PREPARED FOR THE PLAN COMMISSION

Project Address: 223 South Pinckney Street (District 4- Ald. Verveer)
Application Type: Demolition Permit, Planned Development Alteration, Conditional Use, and Certified Survey Map
Legistar File ID # [55916](#), [55921](#), [56121](#), & [56288](#)
Prepared By: Kevin Firchow, AICP, Planning Division
Report includes comments from other City agencies, as noted
Reviewed By: Heather Stouder, AICP, Planning Division Director

Proposal Summary: This request includes modifications to an approved 253-unit hotel and mixed use building to remove one underground level and associated onsite parking, with corresponding façade alterations. As part of this proposal, the applicant also requests re-approval of the conditional use for select projections above the Capitol Height Limit. The City Parking Utility also requests re-approval to demolish the Government East Parking Garage. Finally, a two-lot Certified Survey Map is proposed to divide the subject property into two lots.

Above: West Wilson Street - Lower Levels of Hotel
March 22, 2017 Plans

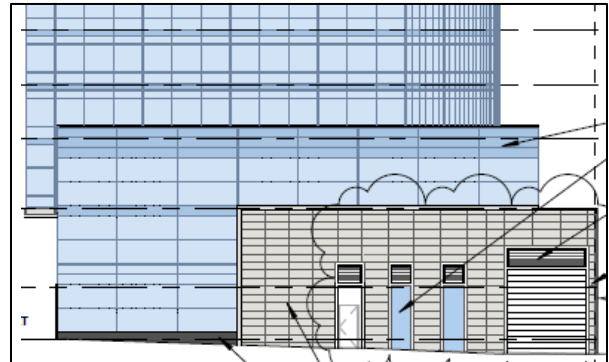
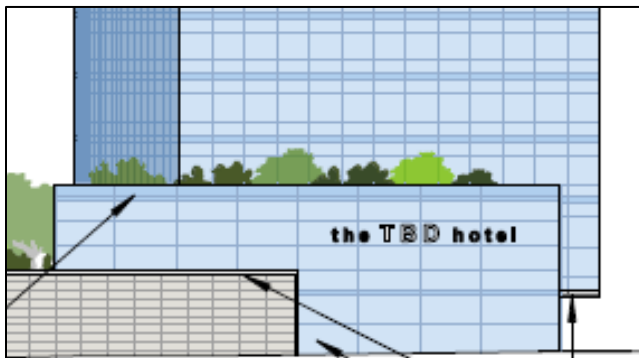
Corresponding façade changes are proposed to the East Wilson and Doty Street facades. Along Wilson Street, the previously approved underground parking entrance is now comprised of a door and spandrel-clad panels. Along Doty Street, additional windows and doors to an enclosed bike parking area are now proposed. No changes are proposed along South Pinckney Street.
